Meeting Minutes

The Children's Hospital Westmead Stage 2 – Health Infrastructure / Parramatta Council Meeting

City of Parramatta Council SSDA Submissions

Figure 3.9 P6 visitor car park boomgate peak period profile

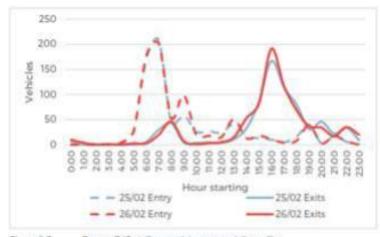
Comment: The architectural plans provided indicates that the parking dimensions proposed will be 2.4m wide and 5.4m long. This will need to be amended to comply with the Australian Standards for Class 3 vehicles (i.e. 2.6m wide and 5.4m long).

- Visitor and staff boom gate activities were monitored as part of the study to understand the ingress/egress patterns.
- The lack of activity in between the two peak periods indicates longer stay with minimal short stay high turnover demand.
- Considerations for the use of Class 2 car parking spaces:
 - Importance of the architectural grid and column sizes for the design of the PSB building,
 - Minimal dimension and operational difference between Class 3 (2.6m) and the proposed Class 2 (2.5m) car parking spaces, and
 - Low-turnover currently reflected in existing visitor and staff car parks.
- Additionally, car parking in this area provided as interim usage of space only.

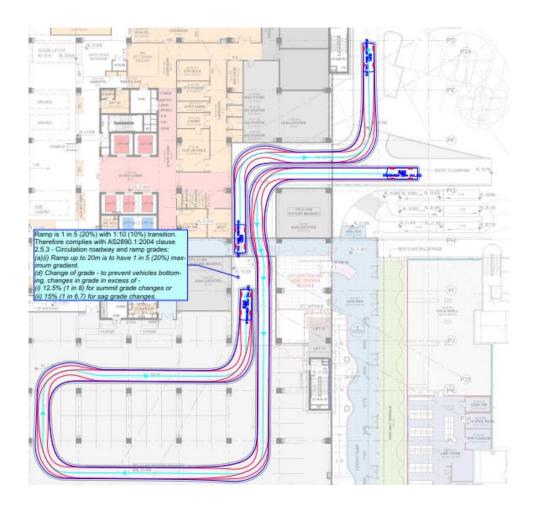
Comment: The architectural plans provided indicates that the parking dimensions proposed will be 2.4m wide and 5.4m long. This will need to be amended to comply with the Australian Standards for Class 3 vehicles (i.e. 2.6m wide and 5.4m long).

- The spaces are proposed to be 2.5m wide (Class 2, AS2890.1). The width of the spaces was limited to 2.5m due to the standard grid and column sizes required from an operational and structural perspective.
- Limited difference in Class 3 vs Class 2 (based on turnover)
 - Class 3 is generally defined for short-term parking with the design criteria requiring **full opening for all doors** and 2.6m wide angled (90 degrees) parking spaces. It is understood that hospital and medical centres were used as examples for Class 3 in AS2890.1.
 - Class 2 is generally defined for medium-term parking with the design criteria requiring **full opening for all doors** and 2.5m wide angled (90 degrees parking spaces). Long-term city and town centre parking were used as examples for Class 2 in AS2890.1.

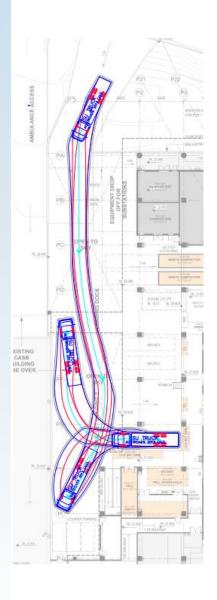
Comment: Swept path plans for the PSB car park; particularly for the ramp; have not been provided to demonstrate satisfactory on-site manoeuvring and therefore, cannot be peer reviewed.

- This will be provided as part of the RtS.
- Swept path has been completed and design allows for concurrent movements of a B85 and B99 compliant with AS2890.1

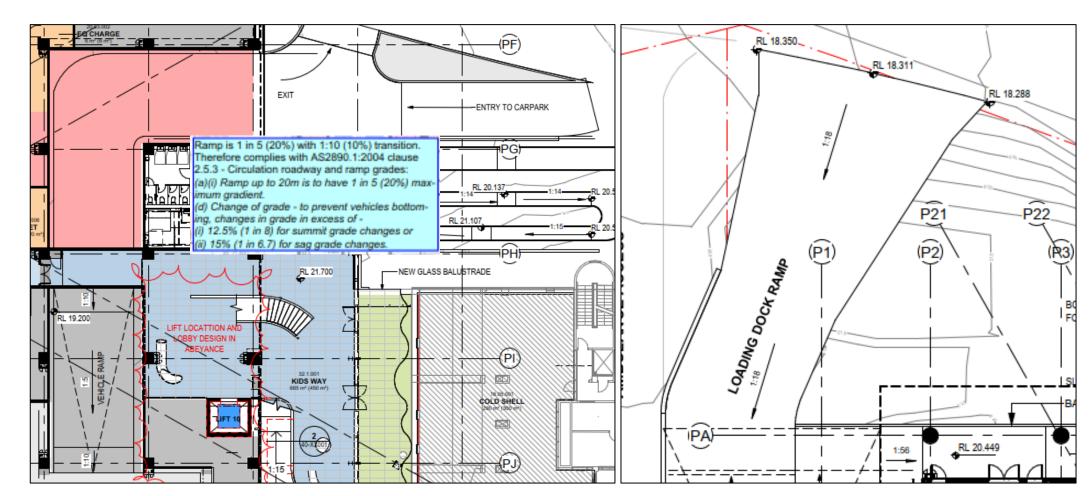
Comment: Driveway and ramp gradients for both the PSB carpark and Loading Dock have not been provided and cannot be peer reviewed.

- This will be provided as part of the RtS.
- Ramp grade for car park is 1 in 5 with 1 in 10 transitions. **Compliant with AS2890.1** maximum grading for ramps (1 in 5) and transitions (1 in 6.7)
- Ramp grade for loading dock is 1 in 18. **Compliant with AS2890.2** maximum grade change (1 in 16)

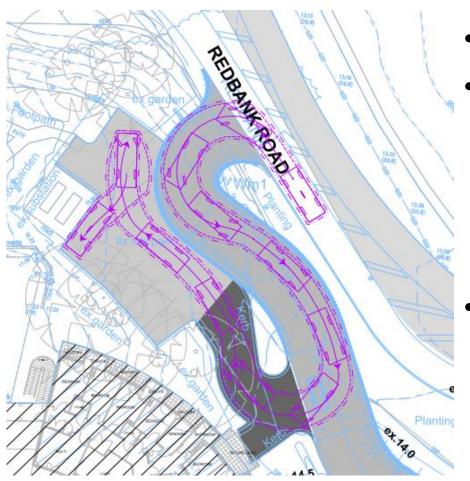
Comment: It is recommended that a pick-up/drop-off facility be provided within close vicinity to the PSB entrance as this would provide a convenient and designated area for staff or visitors to pick-up/drop off passengers.

- As part of Parramatta Light Rail (subject to separate planning approval) a designated pick-up/drop-off facility for the CHW is provided on the corner of Hawkesbury Road and Hainsworth Street.
- The PSB can be accessed from this area via the new pedestrian canopy link proposed as part of this development, connecting the PSB to the CHW forecourt and pick-up/drop-off area.

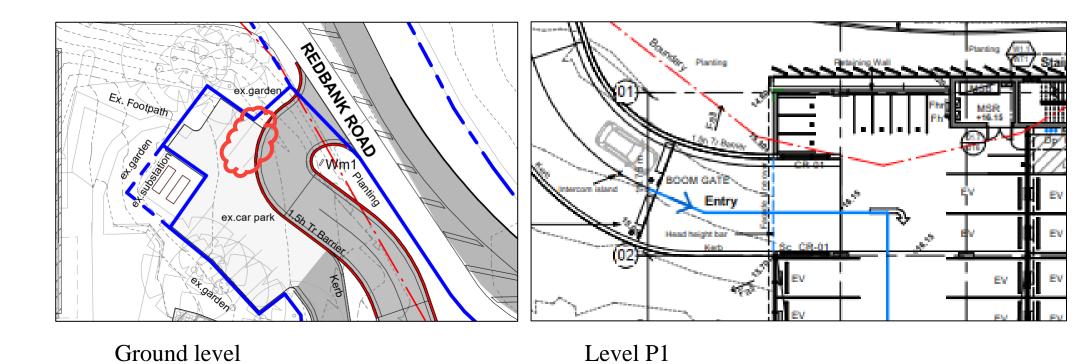
Comment: It is unclear whether the car space under the entry ramp has enough headroom as RLs were not provided. This is to be clarified.

• Spaces to be removed. Anticipated only one space is needed in this area

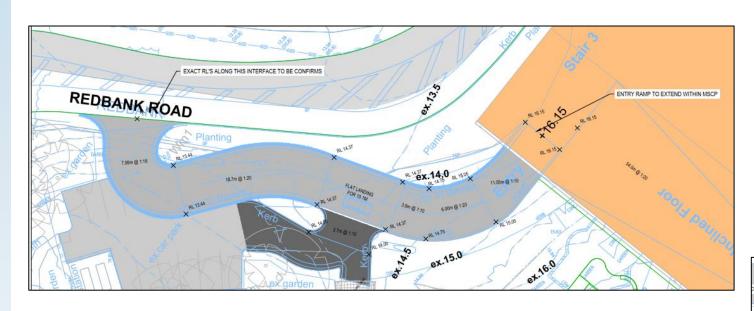
Comment: Entry and exit ramp gradients were not provided and therefore cannot be peer reviewed. Note that ramp gradients will have to comply with Clauses 2.5 and 2.6 of AS2890.1-2004.

- This will be provided as part of the RtS.
- Entry ramp grade is max 1 in 10 with max 1 in 10 transitions. **Compliant with AS2890.1** maximum grading for ramps (1 in 5) and transitions (1 in 6.7)
- Entry ramp grade is max 1 in 6.5 with 1 in 10 transitions. **Compliant with AS2890.1** maximum grading for ramps (1 in 5) and transitions (1 in 6.7)
